NUMBER: 23-009-12 REV. A

Incorrect Rear Door Trim Panel

2012 (LX) 300

Fig. 1 Left Rear Door Trim Panel

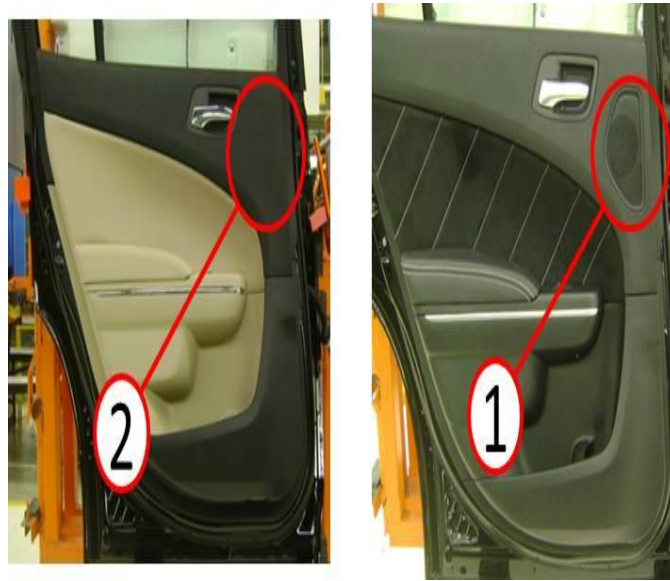
1. Inspect the right and left rear door trim panel for speaker grills(Fig. 1).

2. ****Did the rear door trim panels have speaker grills?**
 - a. Yes>>> Return the vehicle to the customer or dealer inventory.
 - b. No>>> Proceed to [Step #3](#).**
3. Remove and replace both rear door trim panels. Refer to the detailed procedures available in DealerConnect >TechCONNECT > under: Service Info > 23-Body > Doors - Rear > PANEL, Rear Door Trim > Removal/Installation.
